**Project #22-005
Westfields Lofts
Located at approx. 1115 W 130 S**

REPORT SUMMARY...

Project Name: Westfield Lofts
Proponent / Owner: Tony Johnson / HRT Holdings
Project Address: ~ 1115 West 130 South
Request: Design Review Permit
Current Zoning: Commercial (COM)
Type of Action: Quasi-Judicial
Hearing Date: Jan. 27th 2022
Submitted By: Russ Holley, Senior Planner

Figure 2 shows the proposed site plan

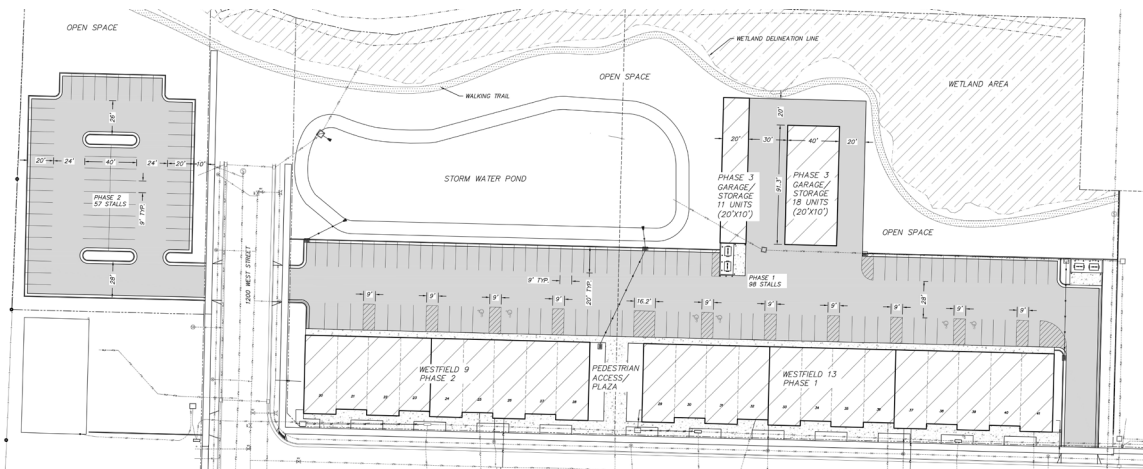
The proposed project shows two buildings with a total of 44 residential dwelling units for a total residential parking requirement of 88 stalls. Commercial parking is assessed and required at the time of a business license or building permit. Both buildings combined contain 33,000 SF of ground floor commercial space. At the high end (if all businesses are retail or similar), the commercial parking requirement would be 132 stalls. At the low end (if all businesses are shop/contractor space), the commercial parking requirement would be 66 stalls. The submitted site plan shows a total of 184 parking stalls, including the accessory garage buildings, for both the residential uses and the commercial space. As submitted, the 184 stalls are in between the low end (154 stalls) and the high end (220 stalls). The actual number required for each prospective commercial use will be assessed during the business licensing process.

The applicant is proposing an alternative parking plan that is based on the Institute of Transportation Engineers (ITE) parking demand data which suggests that a parking demand of 123 parking stalls is adequate for this project. Adjusted for time of day demand the consultants suggest 126 stalls be provided for this project. This would be a 19% reduction for the low-end and 43% reduction on the high-end. The LDC allows a maximum reduction of 25% in parking requirements. The document is attached for review and approval by the Planning Commission. As conditioned with parking compliance for residential and all possible business situations, the project meets the requirement of the LDC.

The LDC 17.30 require projects to provide pedestrian and street connectivity. The proposed site layout places the building near the sidewalk edge making walking quick and convenient. The center plaza area allows access from the street to the rear entrances of the apartments. Sidewalks along the streets, rear of the building and walking trail along the wetland provide pedestrian circulation. The separate parking lot across 1200 West does not show a crosswalk. As conditioned with a crosswalk connection from the separate parking lot to the buildings, the project meets the requirements in the LDC.

1. All standard conditions of approval will be recorded with the Design Review and are available in the Community Development Department.
2. The project shall provide 88 parking stalls for the residential apartments.

4. The Planning Commission will decide to accept or reject the alternative parking plan. If rejected, the project shall build 184 stalls as shown on the site plan. If accepted, the project shall build the number of stalls determined by the Planning Commission but shall not exceed a 25% reduction as per LDC.

5. The project shall provide a bike rack.
6. The adjacent building's front facades shall vary at least three of the seven categories in LDC 17.12.020.
7. A crosswalk shall be installed across 1200 West connecting the offsite parking lot to the buildings.
